PARTIAL LEVEL-09 FRAMING PLAN (PHASE-8) (SEQ#47)

SK#23
17 pages
35 Queries
Date: 07-14-2025

PROJECT DESCRIPTION : 1250 MARYLAND AVENUE

DRAWN BY: JSV	DATE: 02-27-2025	PROJ. NO.: 25001	REV #
CHECKED BY: MNK	DATE: 02-27-2025	DWG NO.: E4901	▲
DWG DESCRIPTION : PARTIAL LEVEL-11 FRAMING PLAN (PHASE-8) (SEQ#49)

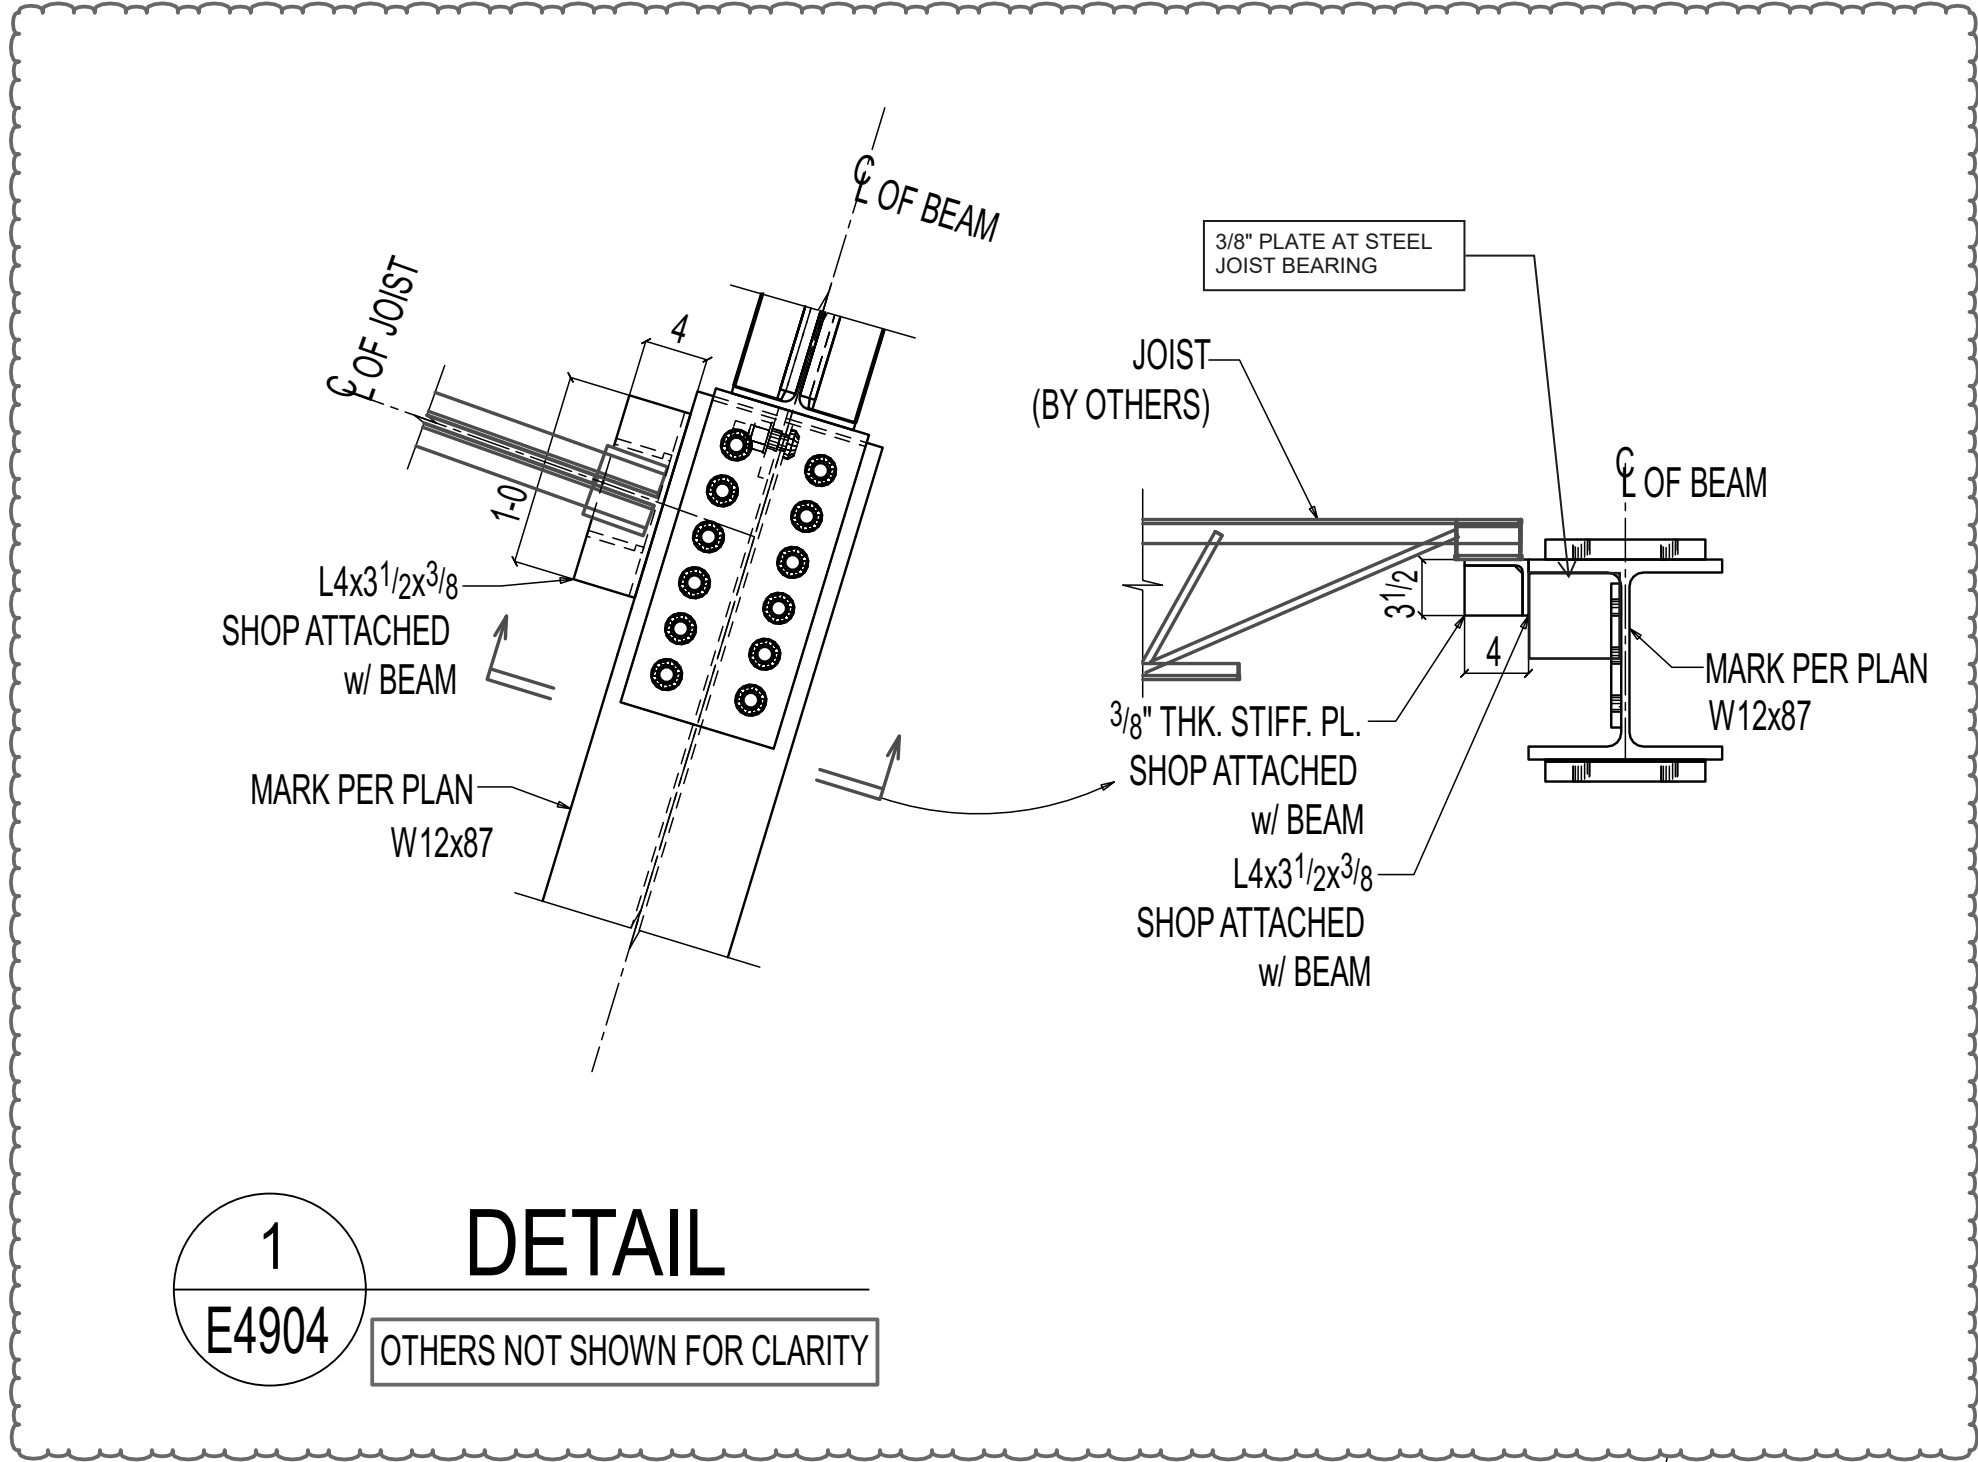
Q10
Please review the green clouded note and confirm the column section size.

APPROVER, PLEASE CONFIRM THE CLOUDED COLUMN SIZE IS OK TO PROCEED?

APPROVER, PLEASE CONFIRM FOR THE CLOUDED BEAM LOCATION WE HAVE REMOVED MOMENT CONNECTIONS AS PER STAIR CO-ORDINATION DRAWING.

APPROVER, WE HAVE FOLLOWED BEARING CONNECTION FOR NOTED BEAMS AS SHOWN IN SECTION 6/E4904 (TYPICAL DETAIL FOR BEAM TO GIRDER BEARING CONNECTION), PLEASE CONFIRM.

Q11
Please review the yellow clouded note and advise.

APPROVER, PLEASE CONFIRM CLOUDED BEAM ELEVATION STRUCTURAL DRAWING S136-E SHOWS EL:158-5 FOR THIS BEAM. BUT WE BELIVE THIS BEAM TOP SHOULD MATCH TOP OF ADJACENT JOIST EL:158-7 1/2. PLEASE CONFIRM.

****APPROVER, DUE TO CONNECTION ARRANGEMENT AND TO PROVIDE ERECTION FEASIBILITY, WE HAVE ADJUSTED THE BEAM WORK POINT OFFSET FROM COLUMN CENTER. PLEASE CONFIRM IF IT IS ACCEPTABLE. (TYP AT SIMILAR CONDITIONS)**

Q12
We have already submitted the connection calculation for this conditions.

APPROVER,
DUE TO THE MOMENT CONNECTION,
WE ARE UNABLE TO SEAT THE JOIST INTO THE BEAM.
THEREFORE, WE HAVE PROVIDED A SEATED ANGLE CONNECTION AS SHOWN.
PLEASE CONFIRM THE SHOWN ARRANGEMENT ARE OK TO PROCEED?
A/E Please Confirm

PARTIAL LEVEL-09 FRAMING PLAN (PHASE-8) (SEQ#47)

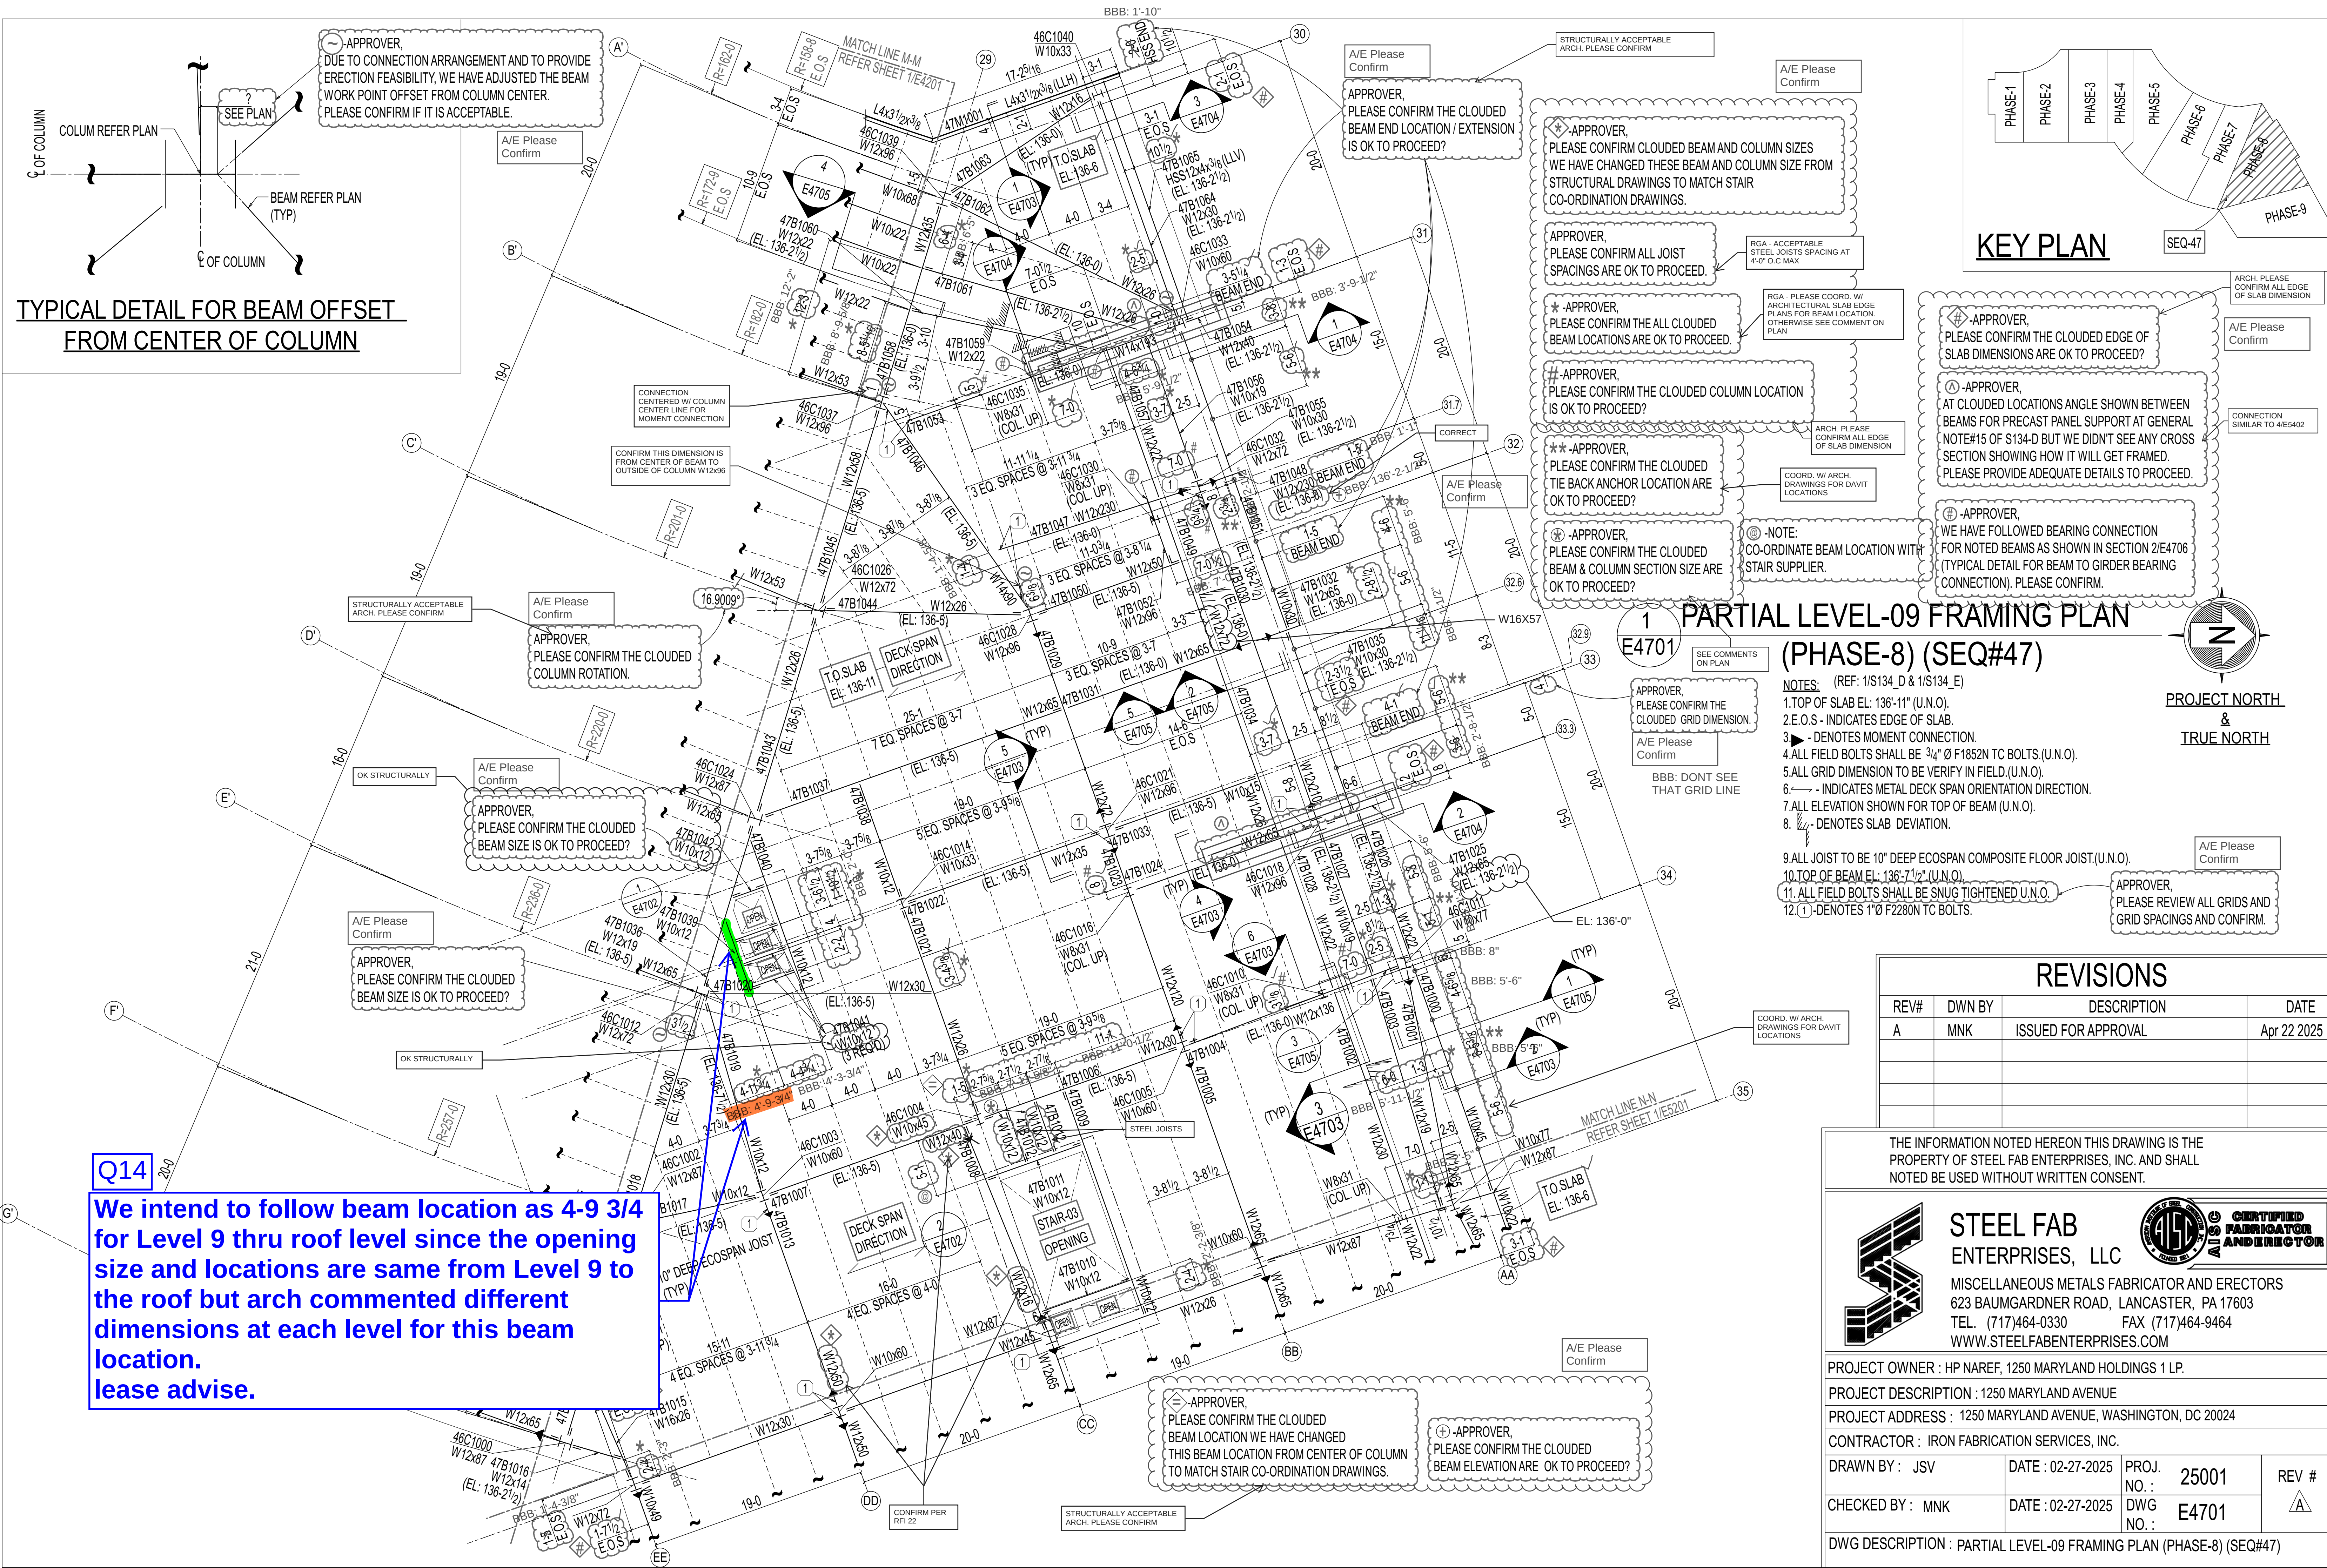
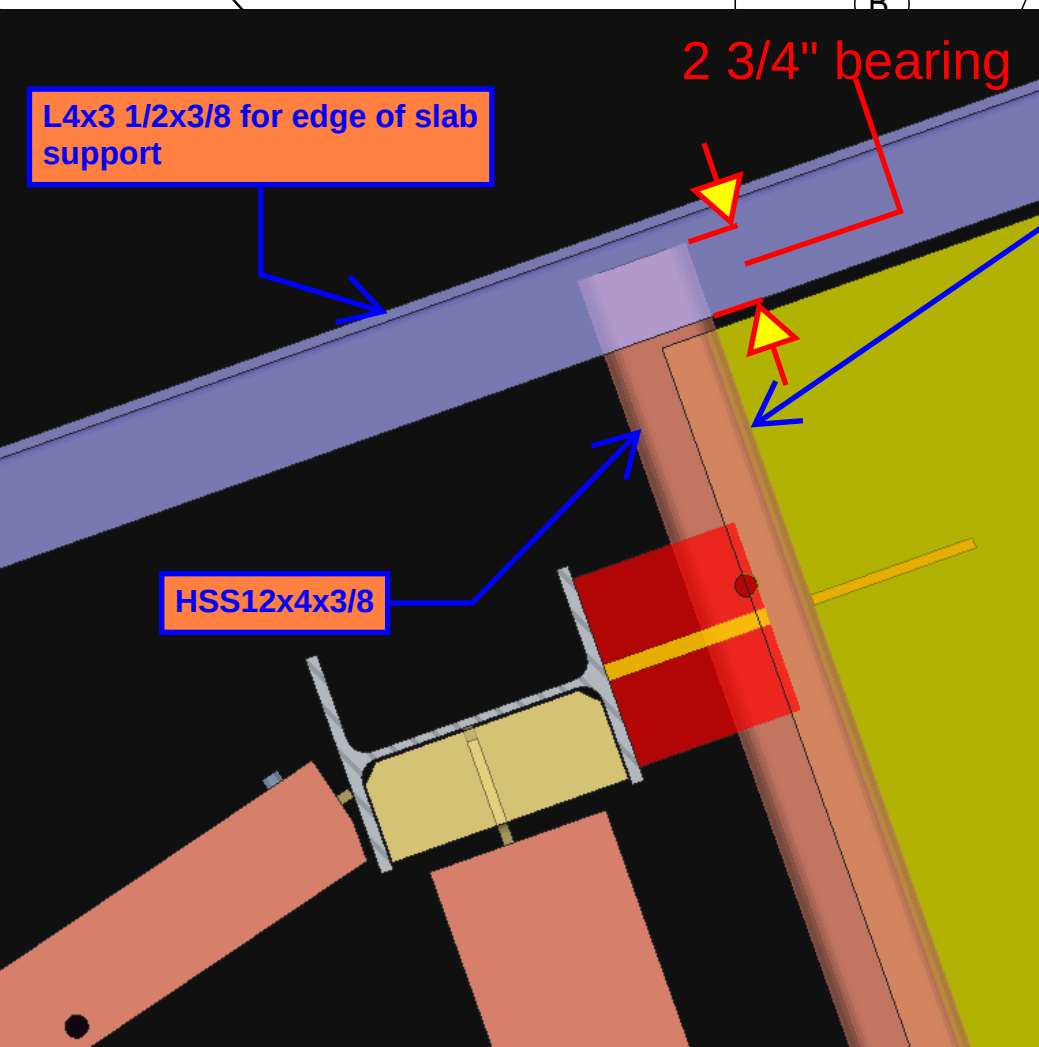
We intend to follow beam location as 4-9 3/4 for Level 9 thru roof level since the opening size and locations are same from Level 9 to the roof but arch commented different dimensions at each level for this beam location. lease advise.

We intend to follow the beam extension as 2'-0" from grid '30' instead of 1'-10" to bear the edge of slab support angle as shown in snap#02. Please confirm.

Arch, Please confirm the magenta clouded beam end location is OK to proceed?

Please confirm the yellow clouded grid 32.9 location from 33.

Please confirm the green clouded beam location 3-6 from grid "AA" is OK to proceed?

We intend to ignore the cyan clouded arch's dimension 7-8 since at phase#7 BFA sheet, arch commented 2-7 & we will follow 2-7 for the same & ignore 7-8.

Please advise.
